Willow Rock Energy Storage Center (21-AFC-02)

Responses to California Unions for Reliable Energy (CURE) Data Request Response Set 1

GEM A-CAES LLC with technical assistance from WSP USA Inc.

23 January 2023

TITLE
CU DR 15-1: MODELED FLAT WEIGHED MAXIMUM NOISE LEVELS FROM CONSTRUCTION

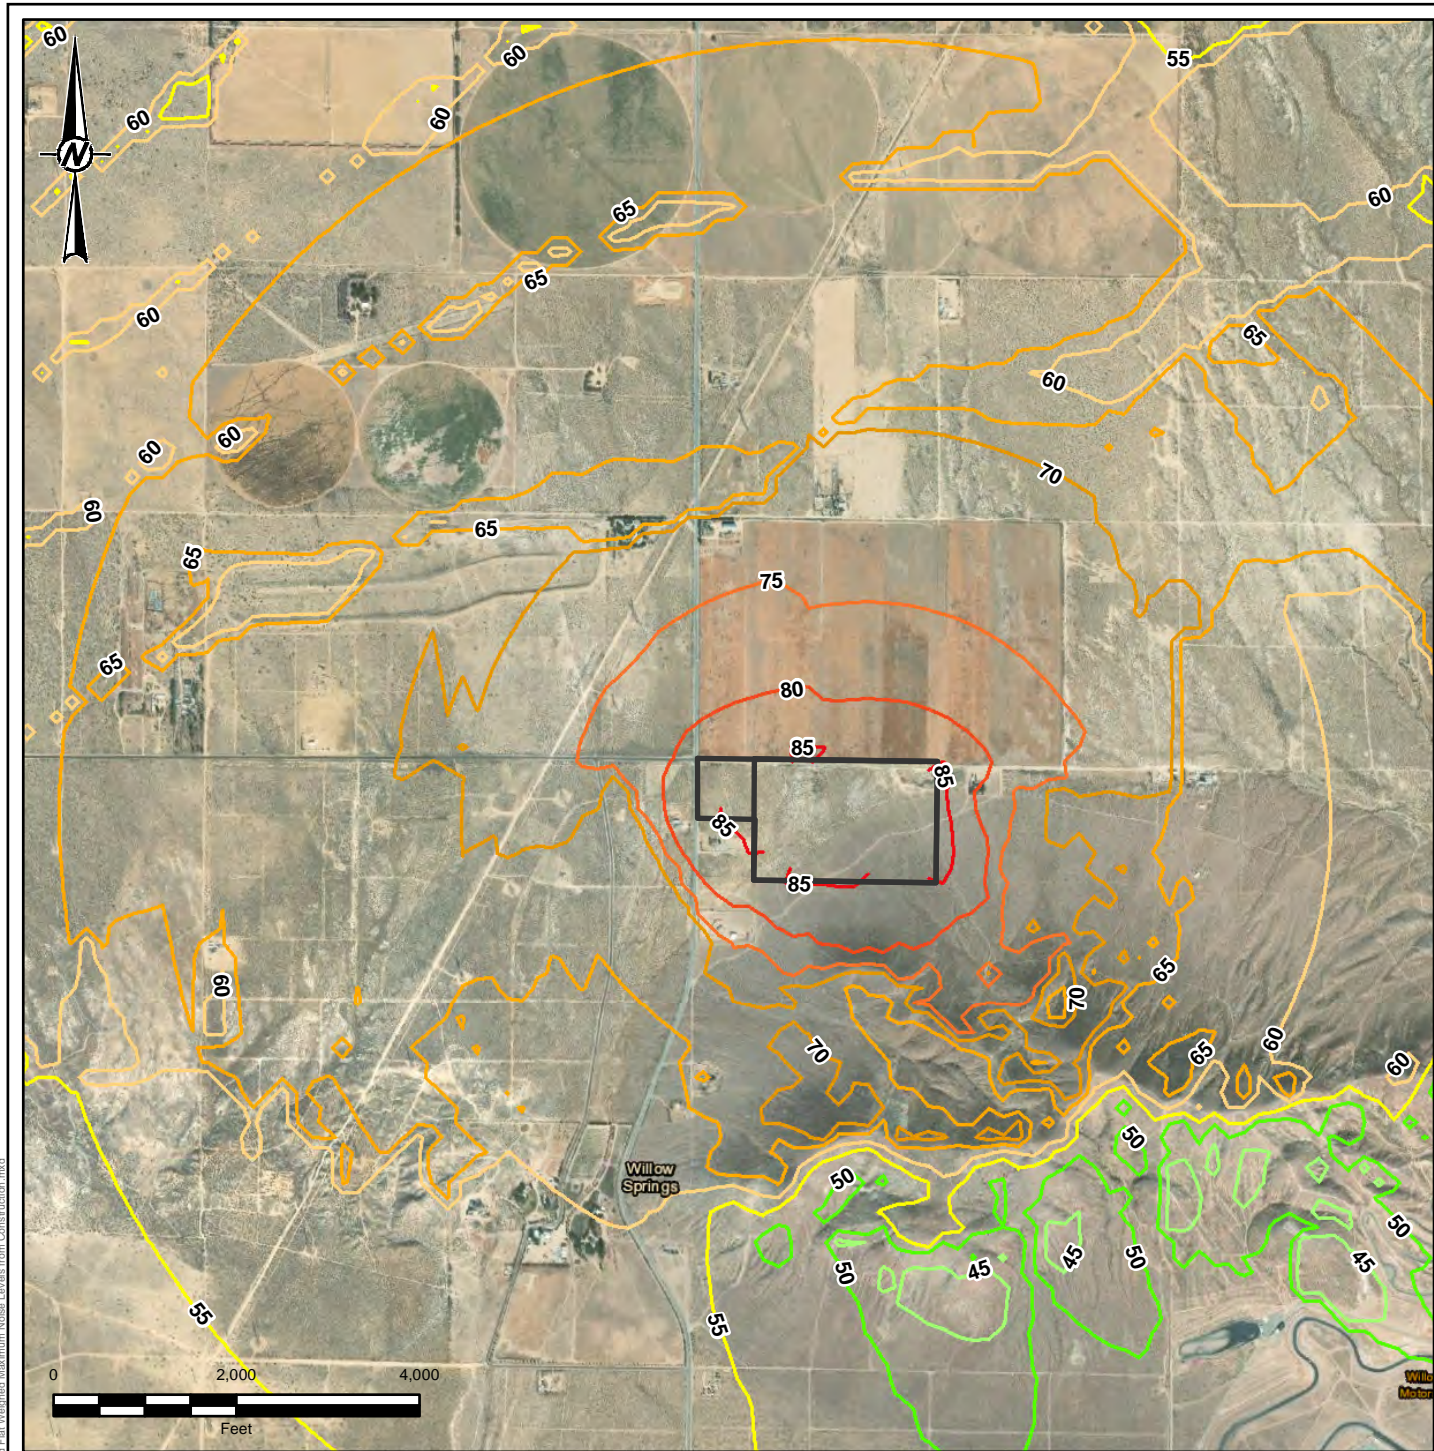
Please provide figures that depict unweighted Lmax and Leq noise contours associated with the Project's construction noise and the Project's operational noise.

Response: The following figures have been provided:

1. CU DR 15-1: Modeled Flat Weighed Maximum Noise Levels from Construction
2. CU DR 15-2: Modeled Flat Weighted Average Noise Levels from Construction
3. CU DR 15-3: Modeled Flat Weighted Average Noise Levels from Operations.

For Project operations the model assumes continuous operation of all equipment; therefore, the Lmax and Leq are represented by the same figure. Please note that these contours may change as a result of Project Optimization activities.
